Re: MM Docket No. 92-132  
File No. BPED-900606MC  
He's Alive Incorporated  
Murrysville, PA

PETITION FOR LEAVE TO AMEND

**AMENDMENT**

## **Amendment to Application for Construction Permit**

**FIGURE 1**  
**PROPOSED HORIZONTAL**  
**PLANE RADIATION PATTERN**

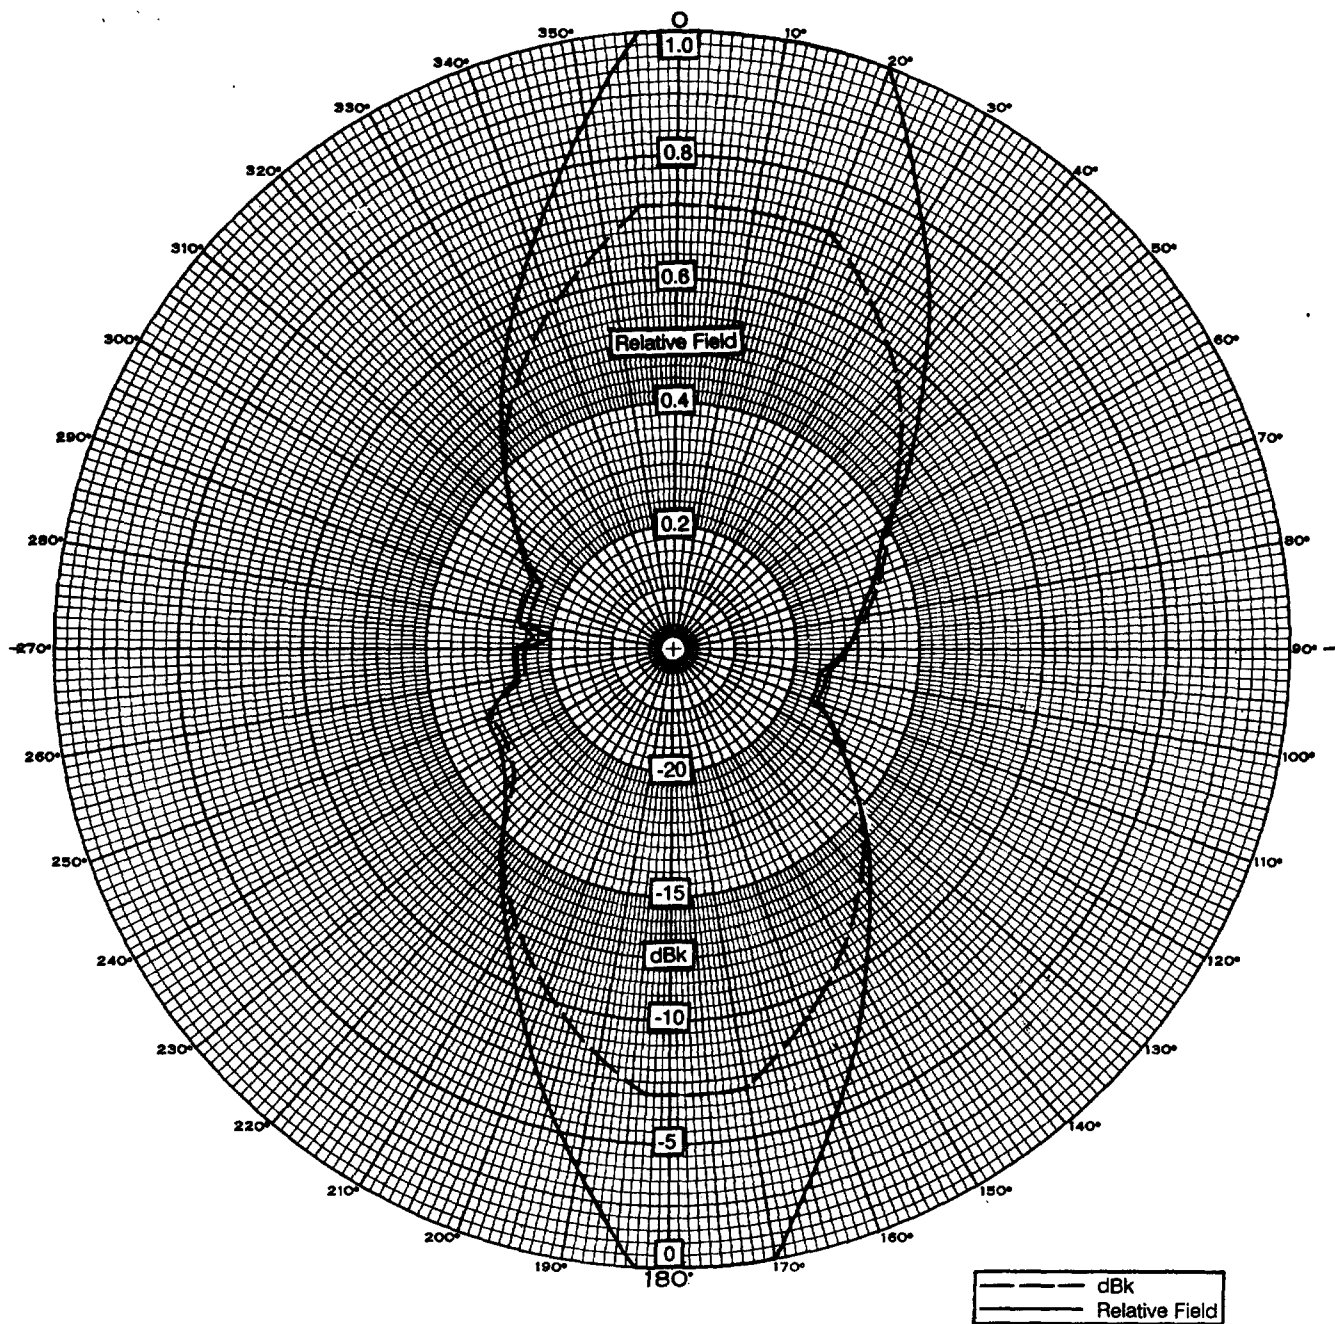
Figure 1 is a directional antenna envelope pattern which shows the permissible radiation from the proposed facility along all azimuths. This is a composite envelope, within which the vertically polarized radiation pattern will be contained. Upon grant of this application, an antenna will be designed to match this pattern as closely as possible without exceeding the pattern limits shown herein.

The proposed envelope pattern does not change by more than 2 dB per 10 degrees of azimuth. The ratio of maximum to minimum radiation is 12 dB, well below the 15 dB limit contained in Section 73.510(b) of the FCC Rules. He's Alive, Inc. is proposing use of a composite Scala antenna system, which will be directionalized to accommodate the pattern requirements. A substitute manufacturer or antenna type may be specified following grant of this application. The antenna make, model and measured antenna pattern will be submitted with the Application for License to cover this construction.
